(M.G. Choubey)
Engineer in Chief,
Water Resources Department,
Bhopal (M.P.)

Endt. No 330/SE(W)/VC/2013

Bhopal, Dated: 23 June, 2016

DRAWING NOT TO SCALE

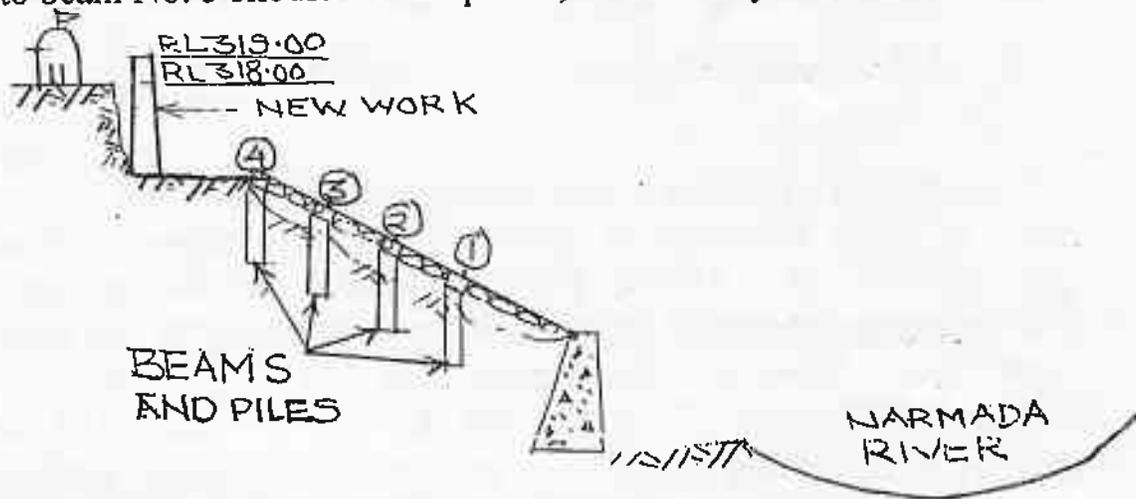
not possible to be laid, as it may rest on built-up ground. Beyond beam No. 4, there is a temple popularly known as Neelkantheshwar Temple. If the bank is not protected, this may threaten the stability of temple.

5. After inspection of site and discussion with the Chief Engineer and the Superintending Engineer, it is decided that the work upto beam No. 3 should be completed, as it is. Beyond beam No. 3

upto beam No. 4 no work should be done. In the portion where spalls and pitching has not been laid, geotextile membrane should be laid below spalls, to avoid flushing of soil or sand. The slopes of the pitching is 1:1 and in some places even 0.9:1. As this work has been done and cannot be relaid completely, it should be kept as it is, except resetting of disturbed pitching. After completion of pitching it should be packed thoroughly to avoid escape of the stone during floods.

6. Regarding portion beyond beam No. 3 upto the edge of the temple, a retaining RCC concrete wall should be proposed. The top R.L. of this wall be kept at 319 m, having weep holes 1.5 m C/C in staggered manner. This retaining wall should be proposed in not more than 10 m long length segments. The foundation should be of friction piles properly designed and capped together above ground. The space between beam No. 3 and retaining wall should be covered with 50 cm thick C.C. M15 in 20 mm. graded metal, sloping towards the retaining

wall, so that the rainwater may not penetrate the pitching base. An open drain 30 cm wide and 30 cm deep should be provided at the toe of retaining wall to drain-out rainwater properly. One catchwater drain of concrete at about 318 m (ground level) should be constructed and joined to the nalla near temple properly to avoid further soil erosion. Retaining wall and allied works like drain etc., should be proposed as a new work and Administrative Approval from the Govt. for this work should be obtained. Beyond beam No. 3, one metre concrete cut-off wall should be provided in the existing contract work to prevent ingress of water underneath pitching avoid material escape by flow of water.
